CERTIFICATE OF APPROPRIATENESS PLACARD

519 E Lane St

COA-0120-2021

RE: 146-18-CA (519 E Lane Street) - Approved with Conditions

2 BACK ELEVATION-PROPOSED Scale: 1/8" = 1'-0"

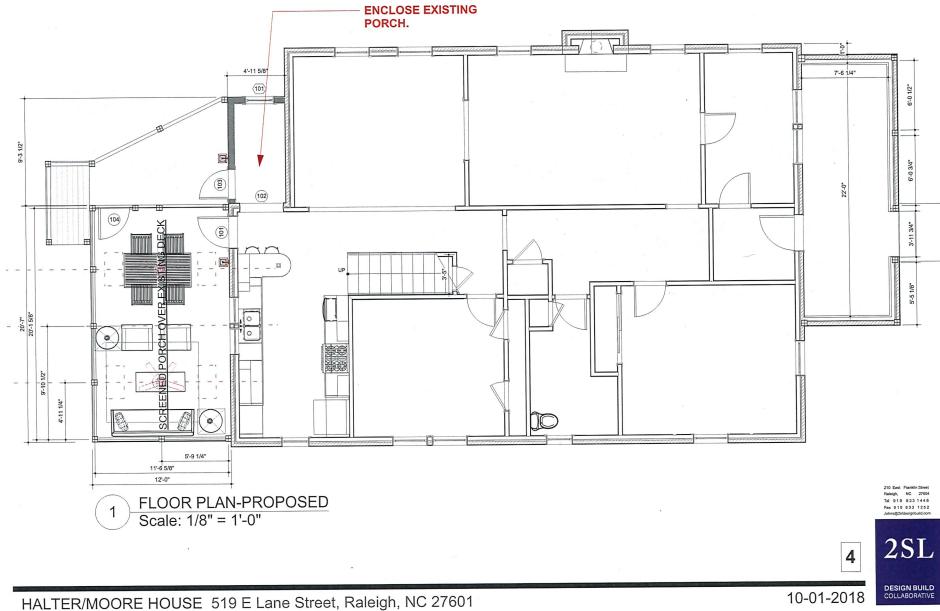
This minor application requests reapproval to enclose a section of the existing rear porch at 519 E Lane St. Page 4 of the included 2018 plans shows this area with a red label entitled "Enclose Existing Porch". This area is currently under the existing roof line.

PLOT PLAN-EXISTING

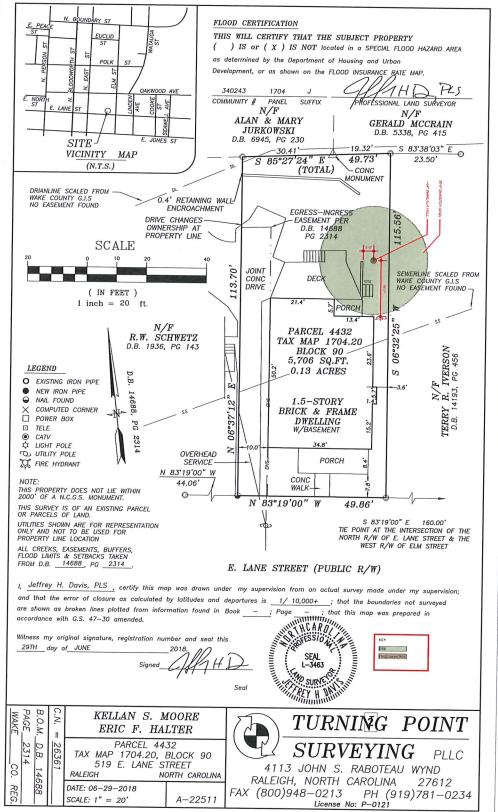
Met 11/12/21 - EM a. Site plan noting the location and critical root zone of regulated trees with roots extending onto the property.

Met 10/13/21 - EM b. Tree protection plan
